## PLAN COMMISSION

Thursday, December 07, 2023 at 4:00 PM

## **MEMO**

Re: Site Plan Review - Enterprise Electric

SOUTH ELEVATION
1/8" = 1'-0"

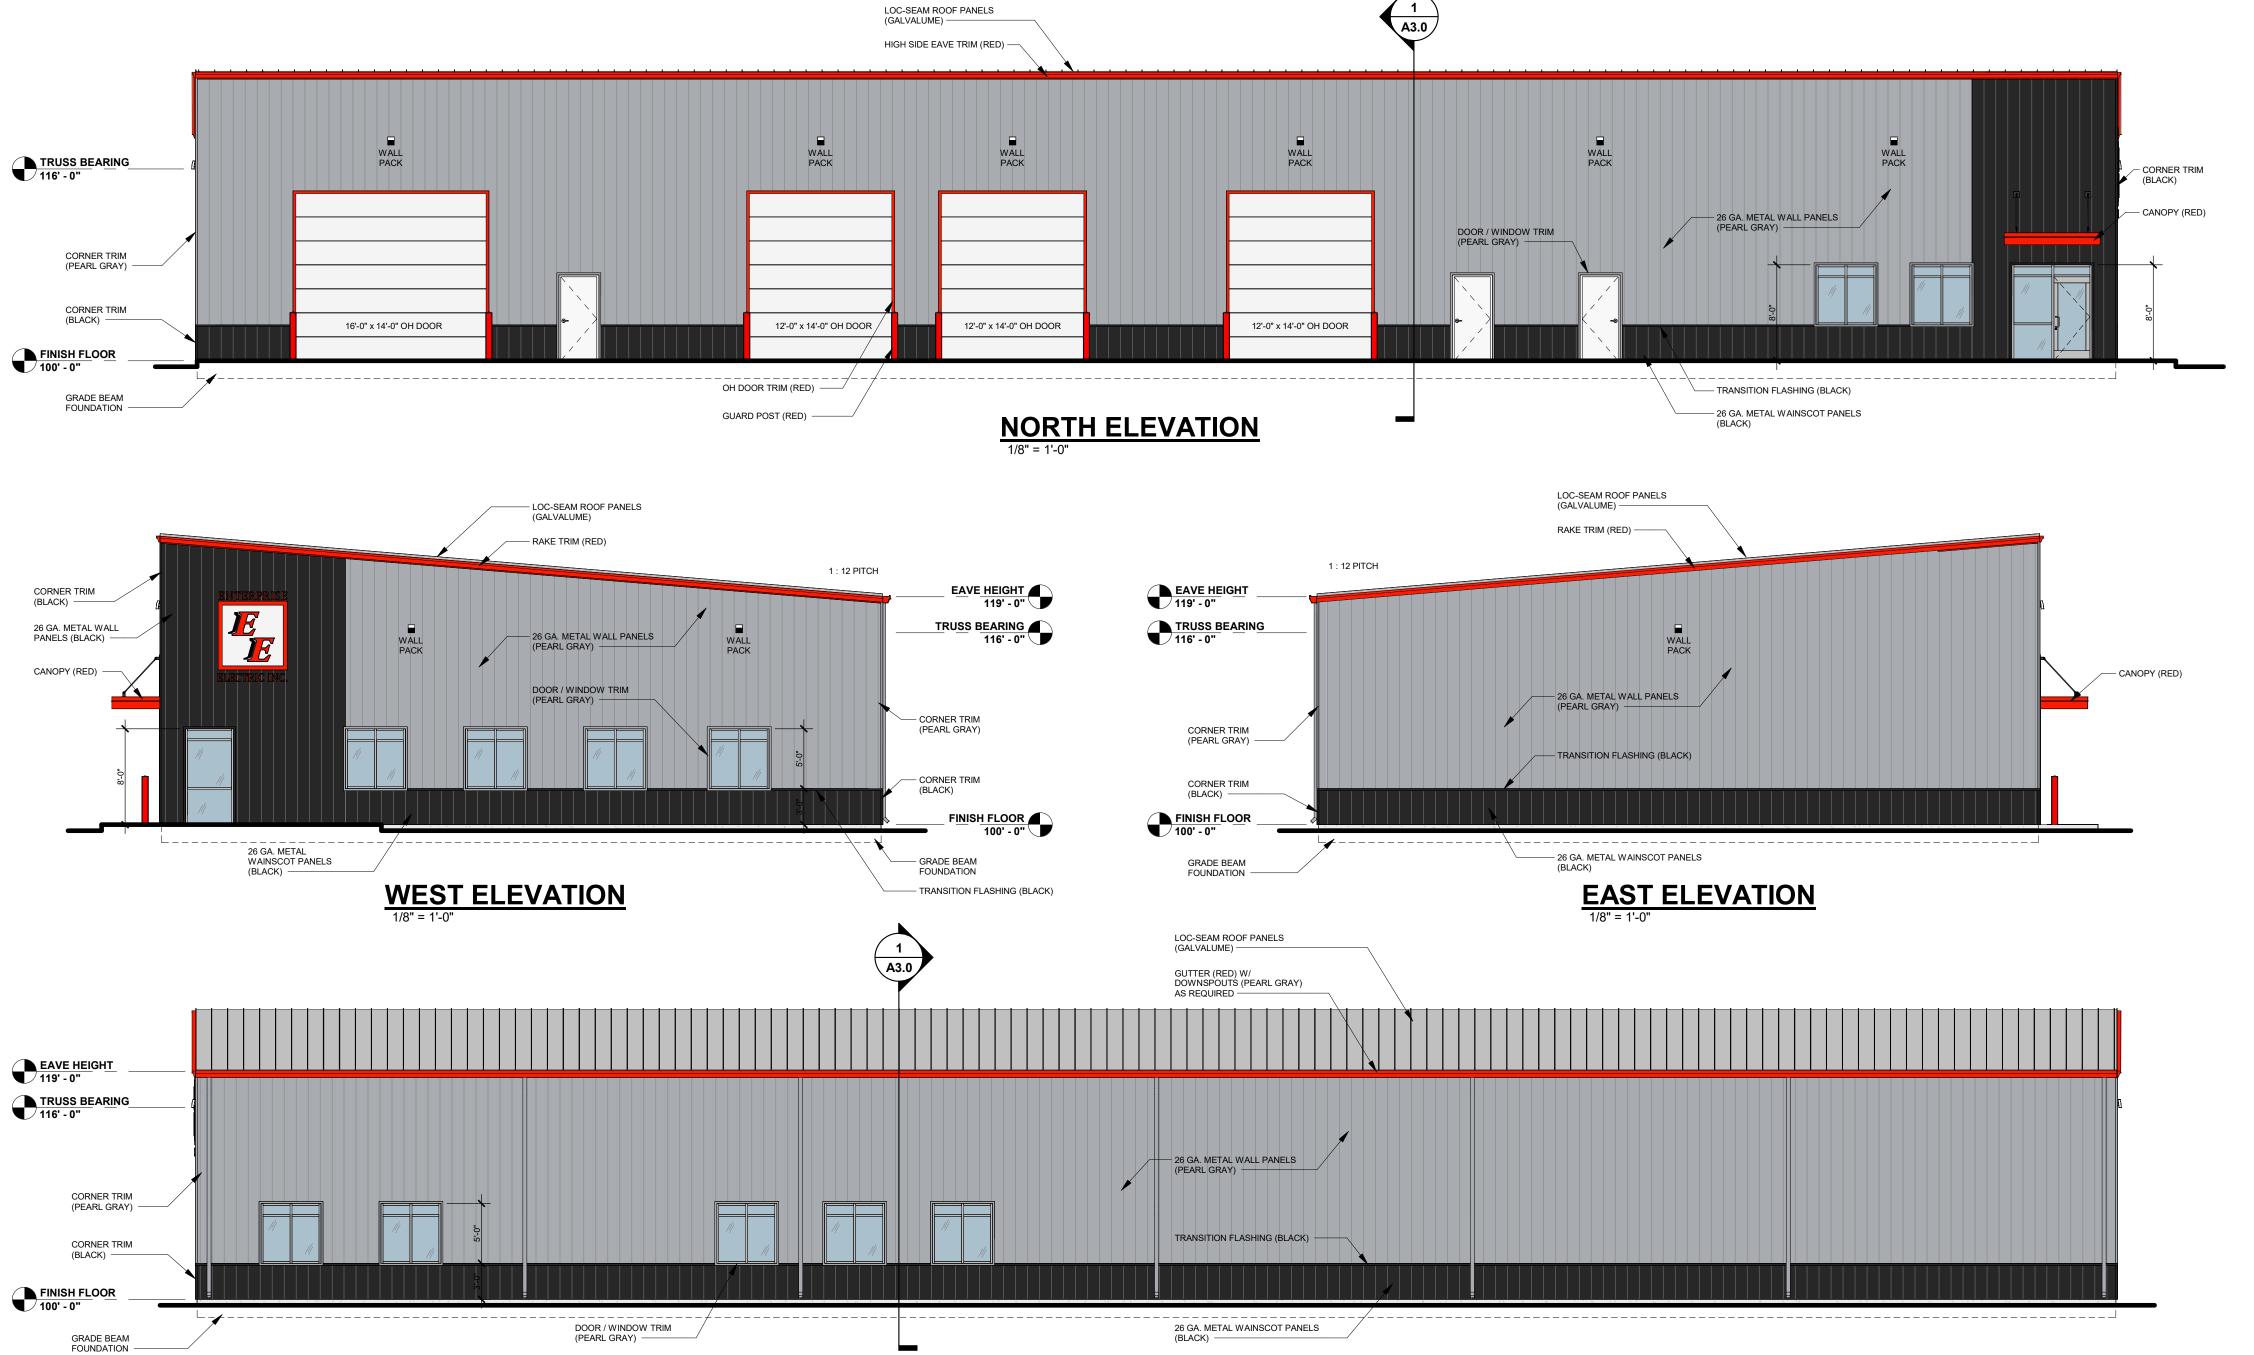
26 gauge metal wall panel in the color pearl gray is the exterior of the building. Masonry wainscoting is required in place of the black metal wainscoting panels. Trim and canopy will be an accent color of red.

- Prior to issuance of building permits, must obtain Stormwater and Erosion Control permits from Engineering Department
  - o Add inlet protection to Existing Inlet 1
- Update façade with a decorative masonry wainscot
- Landscape plan is submitted showing dumpster enclosure and one canopy tree
- Location is shown for snow removal/storage
